**TOWN OF LOS GATOS
PLANNING COMMISSION
REPORT**

MEETING DATE: 06/12/2019

SUBJECT: PLANNED DEVELOPMENT APPLICATION PD-17-002 AND NEGATIVE DECLARATION ND-19-002. PROJECT LOCATION: 16212 LOS GATOS BOULEVARD. PROPERTY OWNER/APPLICANT: 16212 LOS GATOS BLVD. LLC.
 REQUESTING APPROVAL OF A PLANNED DEVELOPMENT TO RE-ZONE TWO PROPERTIES ZONED CH TO CH:PD TO ALLOW FOR CONSTRUCTION OF A NEW COMMERCIAL BUILDING. APN 523-06-010 AND -011.

The CTA marked up the applicant's sheet C-3 dated 10/27/2017 "site plan" by BKF Engineers of San Jose, California. The CTA added the following color-coded items to the sheet for reference purposes:

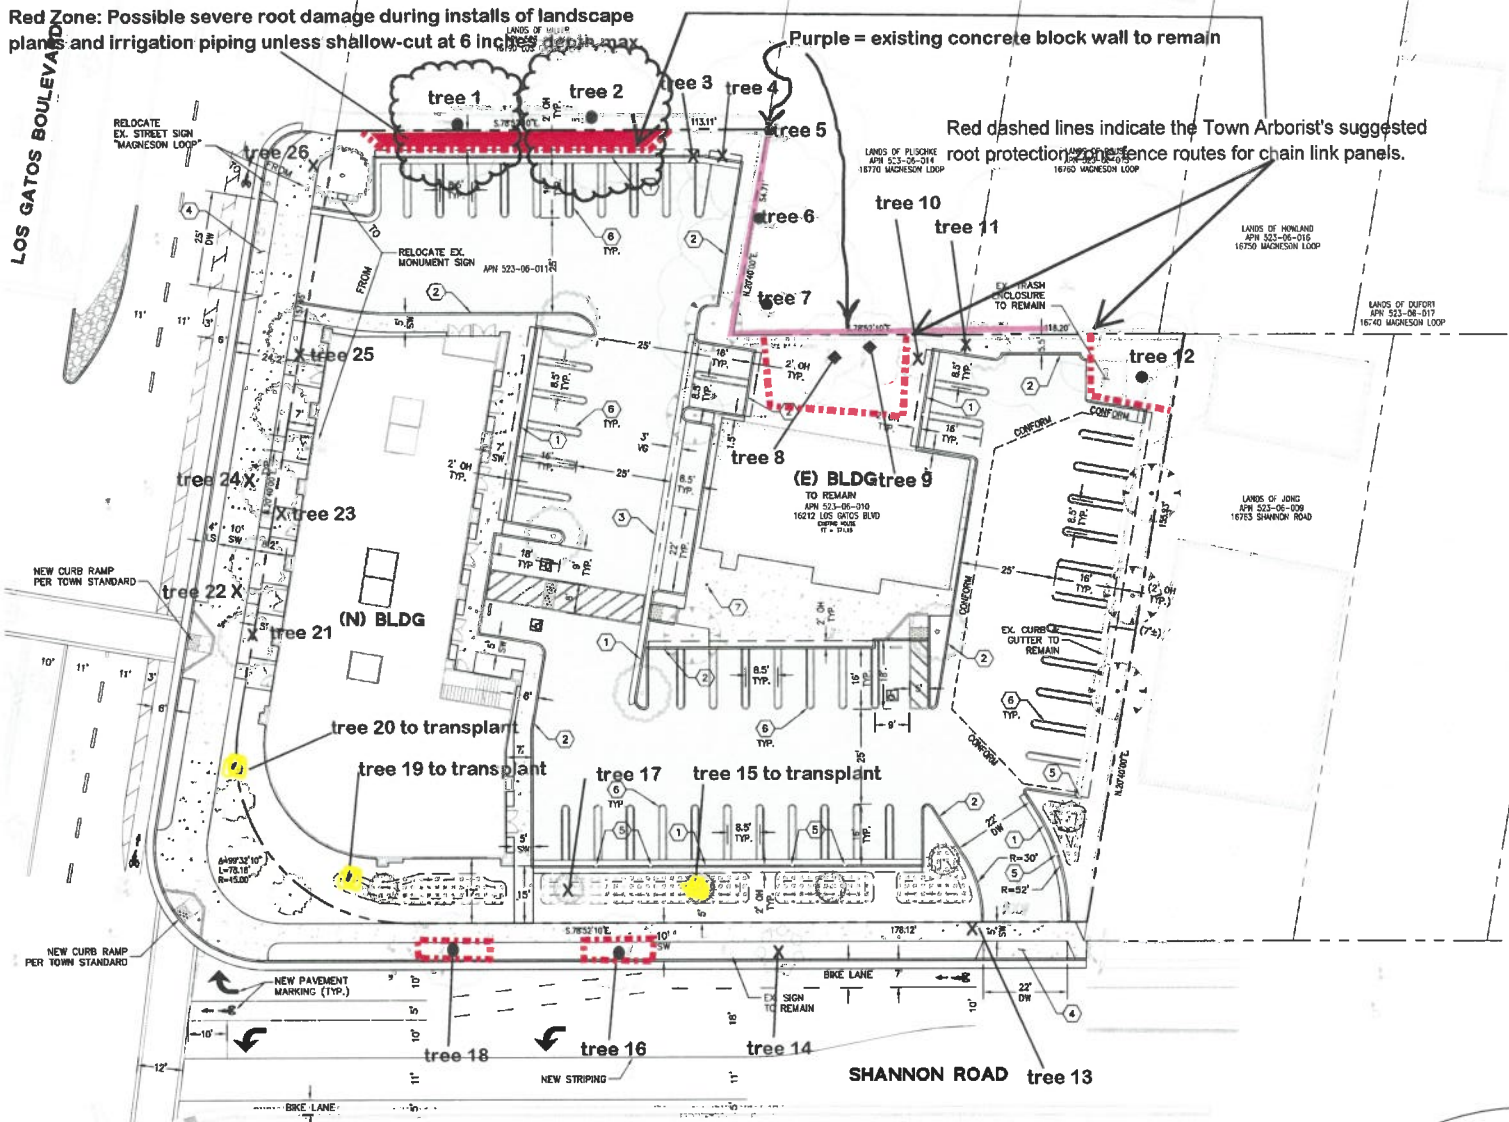
- a. The **red dashed lines** indicate the CTA's suggested chain link root protection fence alignment (initial rough), based on available open soil root zone areas that are protectable (assuming the scope of site plan work will occur as currently proposed).
- b. **Clouding in black lines** indicates the canopy driplines of large neighbor deodar cedar specimens #1 and #2 being retained, which overhang the proposed parking lot area.
- c. The **yellow circles** indicate current proposed trees to be transplanted, as per the applicant's plan set.

Red Zone: Possible severe root damage during installs of landscape plants and irrigation piping unless shallow-cut at 6 inches depth max

View looking southeast at Farley Road intersection

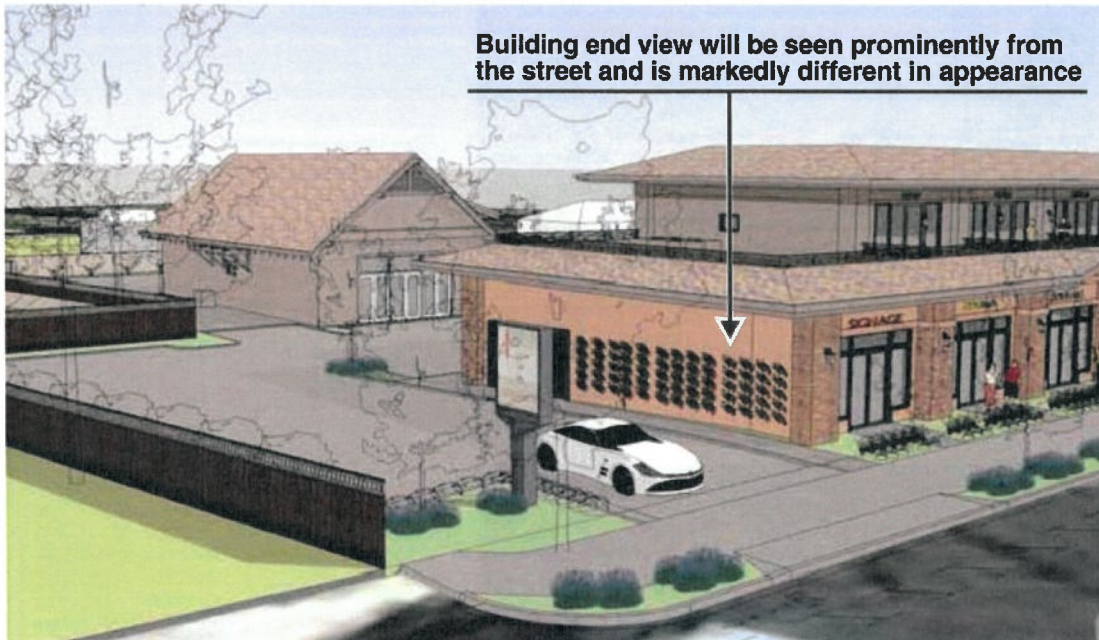
2. The corner treatment seems visually disconnected from the rest of the structure.
3. The single gable at the ground floor on Los Gatos Blvd. seems to imply an entry to one large ground floor tenant.
4. The building is lacking in the abundant detailing called for in the Commercial Design Guidelines.

Second floor at the south end of the building appears to obstruct many views from Los Gatos Blvd. which would not be consistent with the Commercial Design Guidelines

Single gable entry seems to imply a single tenant while multiple entry doors suggest several individual tenants

Site Plan

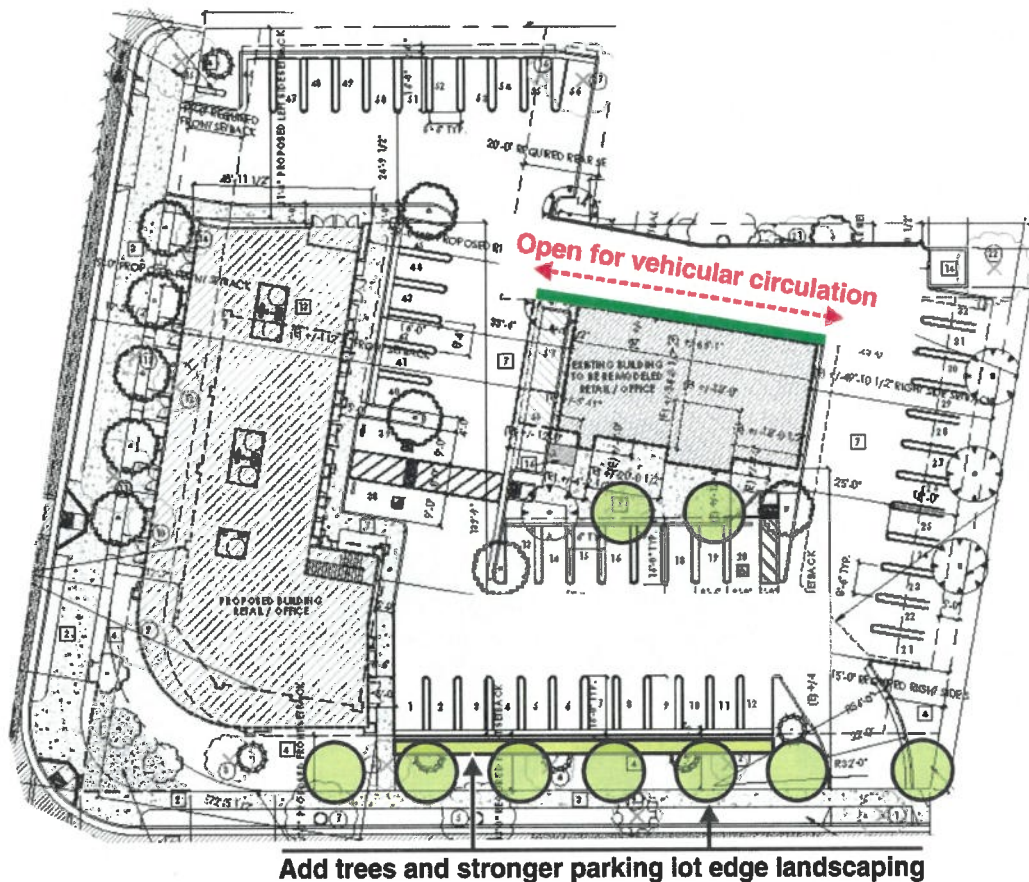
The site plan layout and building design have been created to maximize the development potential of the site which makes recommendations for improvement difficult. However, should staff and the Planning Commission feel that the fundamental approach is acceptable, I would suggest the options below to improve consistency with the Town of Los Gatos Commercial Design Guidelines.

1. Eliminate the dead end parking aisle by providing a driveway behind the pad building.
2. Add trees and stronger parking lot edge landscaping.
3. Add additional landscaping in the parking lot wherever possible.

APPROACH A

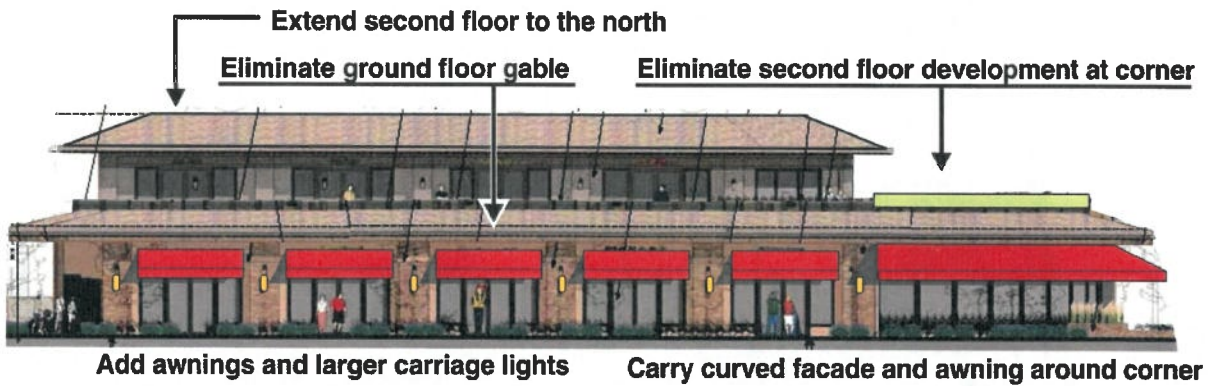
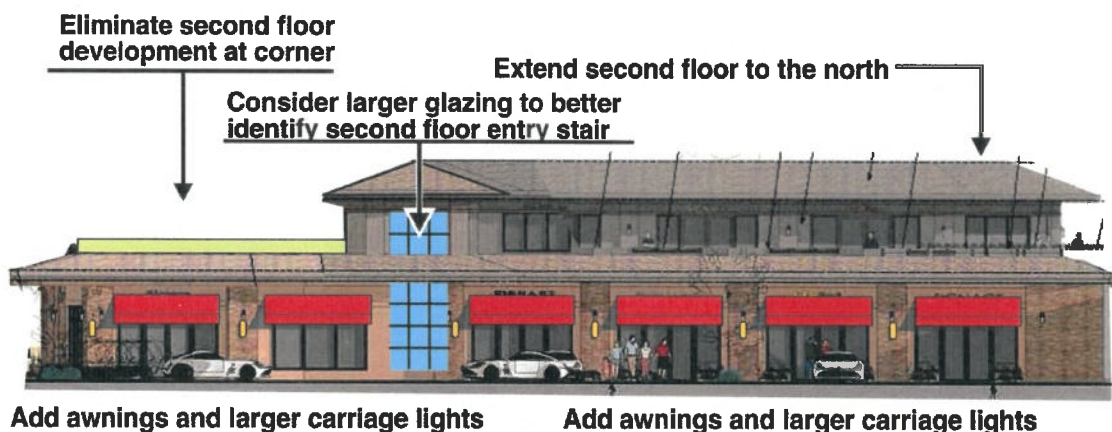
1. Extend the second floor to the north and eliminate the second floor area at the south end of the building.
2. Treat the first floor as individual storefronts. Provide sloped awnings, larger light sconces and other architectural and landscape details. Two examples of pedestrian friendly retail developments are shown in the photos below.

3. Carry the ground floor facade and awning treatment around the corner.
4. Treat the parking lot facade in a similar manner.
5. Consider larger glazing areas to better identify the second floor entry stair.
6. Revise the north facades at both the first and second floors to better reflect the east and west facades.

APPROACH B

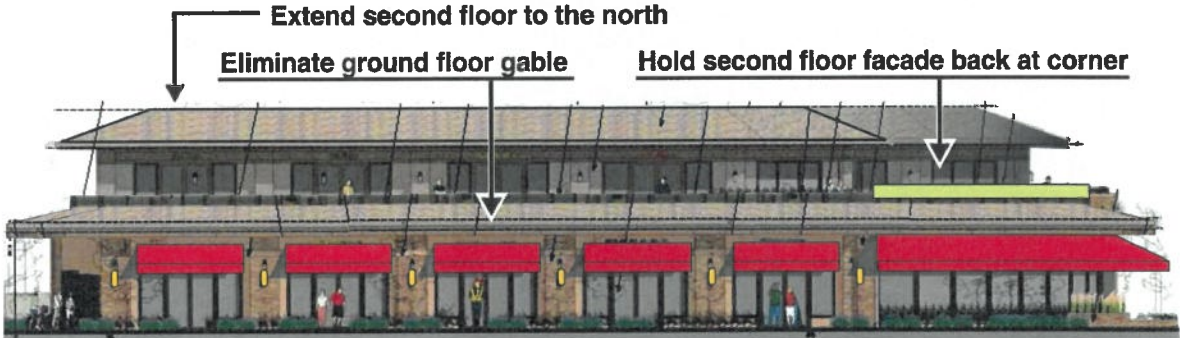
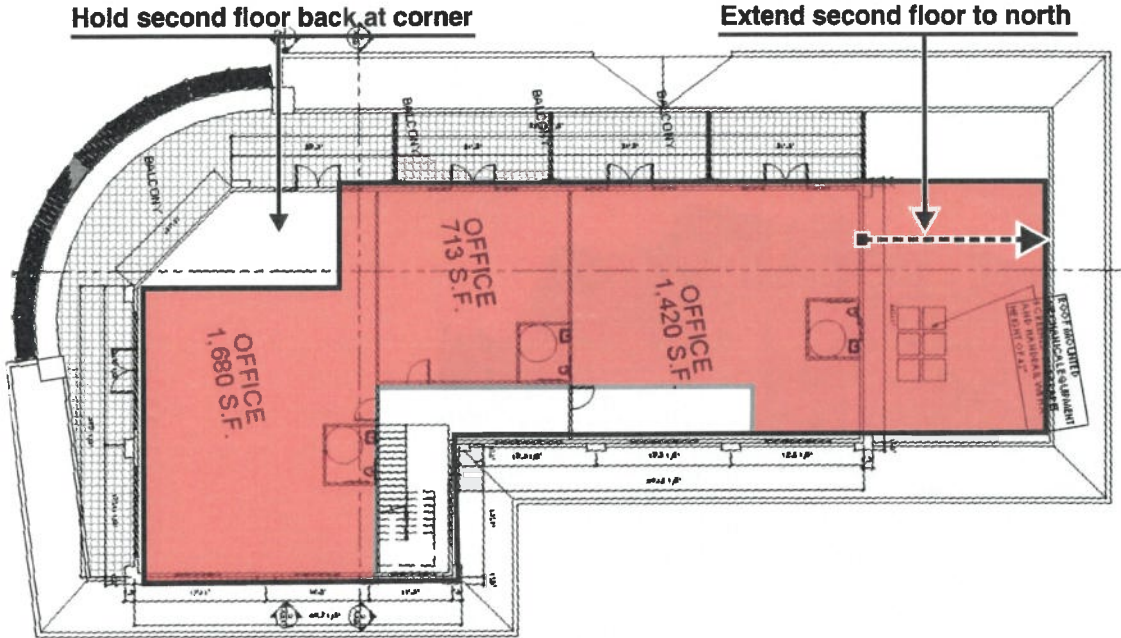
Should staff decide that the elimination of parking spaces to link the dead end parking aisle to the other parking is not needed, and that the blockage of views to the hills would be minor, some smaller modifications could be considered, as shown below:

Add awnings and larger carriage lights Carry curved facade and awning around corner
